Life Cycle Extension of the Krško Nuclear Power Plant
Public Consultation Phase for EIA in the cross-border context

Observations to the documentation concerning the
Environmental Impact Assessment Report

Estensione del Ciclo di Vita della Centrale nucleare di Krško
Fase di Consultazione pubblica per la VAS in ambito Transfrontaliero
(traduzione dell'originale inglese asseverata dagli autori)

Osservazioni alla documentazione inerente al
Rapporto di Valutazione di Impatto Ambientale
(link: <https://va.minambiente.it/it-IT/Oggetti/Documentazione/8450/12466>)

Figure 1: Seismic hazard in Europe, developed in 2013 by the Share project (www.share-eu.org/node/90), with the addition of active nuclear reactors (dots proportional to power). The white arrow points to Krško. (from: Sirovich and Suhadolc, 2015).

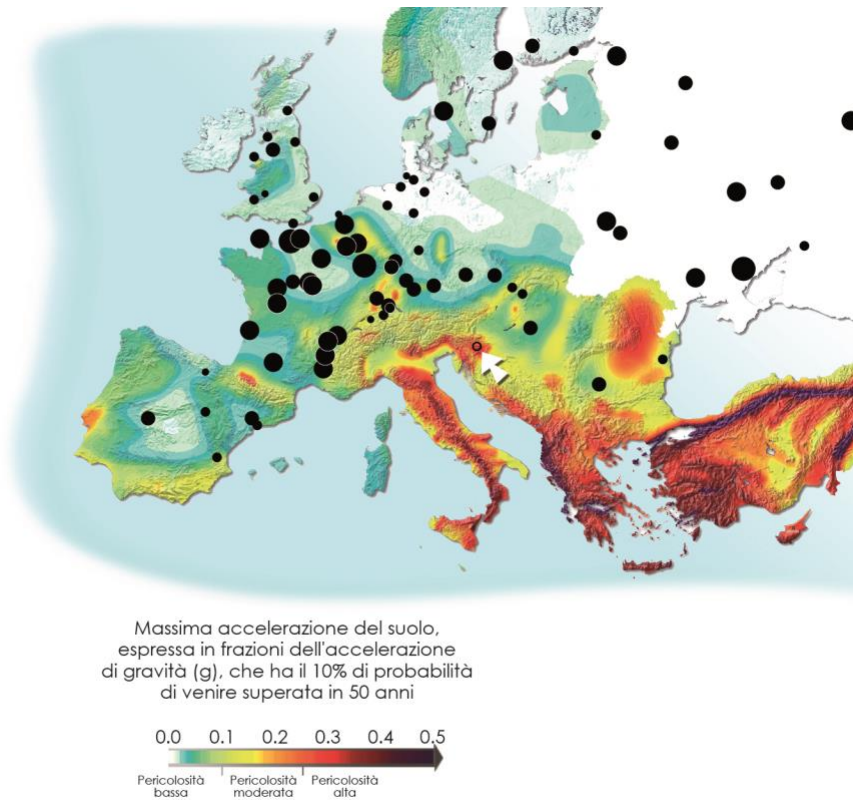
Note: 1) that the seismic hazard (as well as the possibility that a fault could deform the same foundation soils) is one of the most critical parameters in the choice of plant sites, and 2) that the reactor was located in Krško when almost nothing was known about the seismic hazard of the area. It was understood only many years later that Krško is the only power plant in Europe to have been built in a medium-high seismicity zone (see figure 1).

FIG. 7. Attenuation relations for data from Friuli, Italy, showing the tendency for motions on shallow soil sites to be larger than on either rock or deep soil sites (from Chiaruttini and Siro, 1981). *Cutaways* expose patterns on obscured fields.

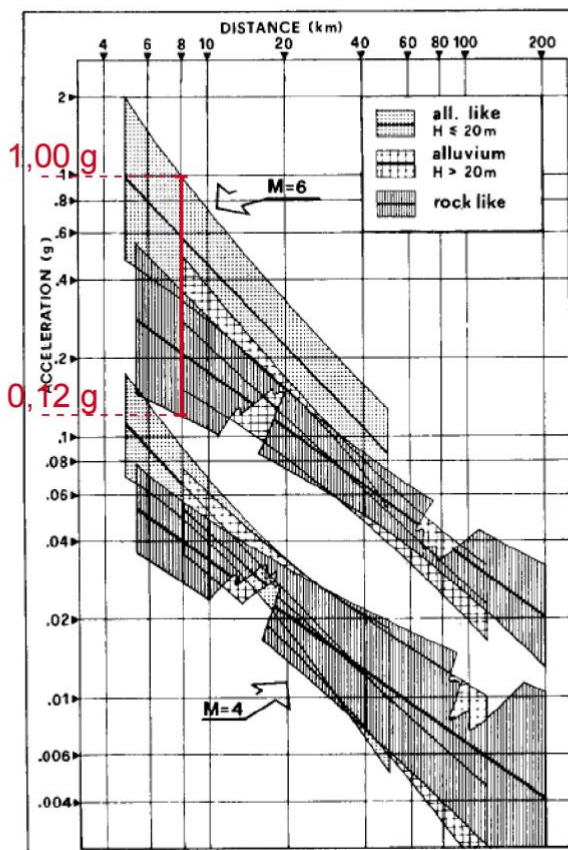
We report here - by way of example - figure 7 (here as figure 2) of the 1982 State-of-the-Art on the specific subject (note: one year before the plant came into operation). The authors are the famous seismologist of the United States Geological Survey (USGS) David M. Boore - at the time director of the Bulletin of the Seismological Society of America (BSSA) - and one of the fathers of the USA seismic zoning (William B. Joyner) (see : BSSA, Vol. 72, No. 6, pp. S43-S60, 1982). The shaded bands represent the 95% confidence intervals.

The figure shows how high the variability of the PGA accelerations is. For example, with magnitude 6, at 8 km from the seismic source in depth (hypocentral distance 8km) there is a 5% probability that the PGA is lower than 0.12g or greater than 1.00g.

In Krško, small tremors often occur at these distances, and earthquakes with magnitudes well above 6 are possible. Figure 2 clearly demonstrates that the PGA values of 0.8 g or 0.9 g, indicated by the designers themselves (as well as by the European stress tests) as a limit for the onset of serious damage to the reactor, are unfortunately *easily overcome* by the earthquakes expected in the area.

Figura 1: Pericolosità sismica d'Europa, elaborata nel 2013 dal progetto Share (www.share-eu.org/node/90), con aggiunti i reattori nucleari attivi (pallini proporzionali alla potenza). La freccia bianca indica Krško. (da: Sirovich e Suhadolc, 2015).

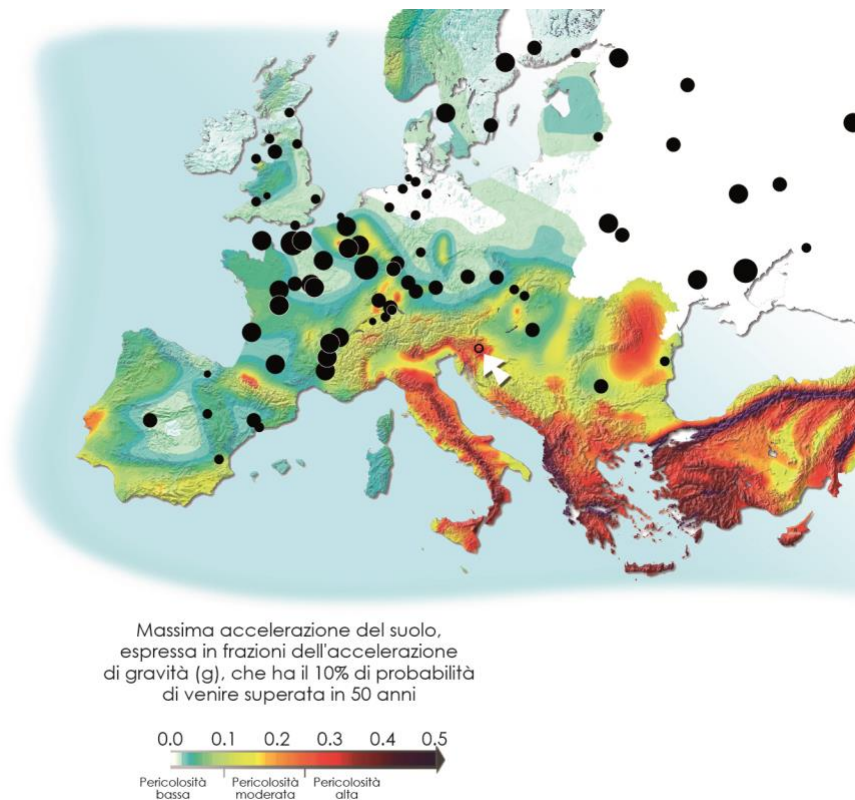
Si noti: 1) che la pericolosità sismica (nonché la possibilità che una faglia possa dislocare gli stessi terreni di fondazione) è uno dei parametri più critici nella scelta dei siti delle centrali, e 2) che il reattore è stato ubicato a Krško quando della pericolosità sismica della zona non si sapeva quasi nulla. Solo successivamente, si è capito che Krško è l'unica centrale in Europa ad essere stata costruita in una zona di sismicità medio-alta (vedi figura 1).

Figure 2: (it was figure 7 in the 1982 State-of-the-Art) Variability of the maximum horizontal ground accelerations (PGA) as the magnitude of the earthquake, the distance from the hypocenter and the geology of the site vary (data from the Friuli earthquake, of 1976).

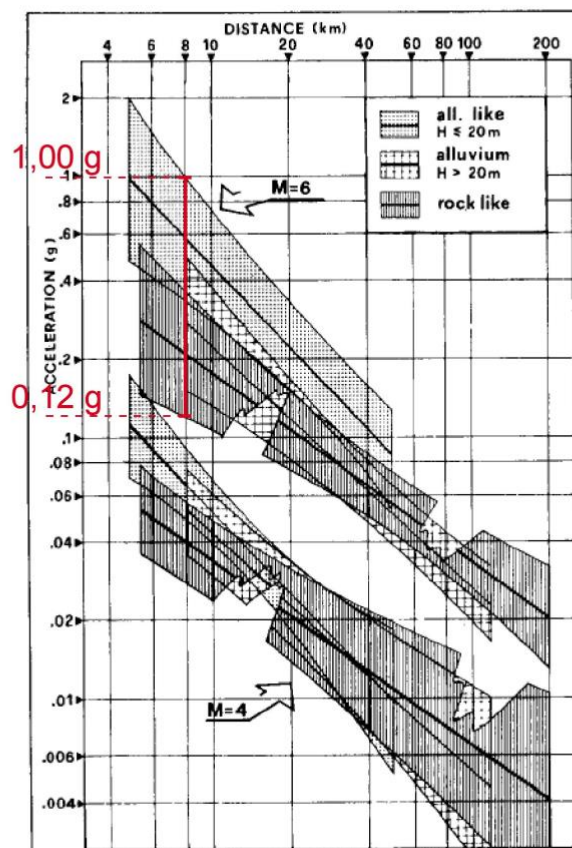
Riportiamo qui - a titolo di esempio - la figura 7 (qui come figura 2) dello Stato dell'Arte sull'argomento specifico, del 1982 (si noti: un anno prima che la centrale entrasse in funzione). Ne sono autori il famoso sismologo dell'United States Geological Survey (USGS) David M. Boore, all'epoca direttore del Bulletin della Seismological Society of America (BSSA) e uno dei padri della zonazione sismica americana (William B. Joyner) (vedi: BSSA, Vol. 72, N. 6, pp. S43-S60, 1982). Le fasce oblique rappresentano gli intervalli di confidenza al 95%.

Dalla figura si vede quanto sia alta la variabilità delle accelerazioni PGA. Ad esempio, con magnitudo 6, a 8 km dalla sorgente sismica in profondità (distanza ipocentrale 8km) c'è il 95% di probabilità che la PGA sia compresa tra 0,012g e 1,000g.

A Krško avvengono spesso piccole scosse a queste distanze e sono possibili terremoti con magnitudo ben superiore a 6. La figura 2 dimostra chiaramente che i valori di PGA pari a 0,8 g o 0,9 g, indicati dagli stessi progettisti (nonché dagli stress test europei) come limite per l'insorgere di gravi lesioni al reattore, sono purtroppo facilmente superabili dai terremoti attesi nell'area.
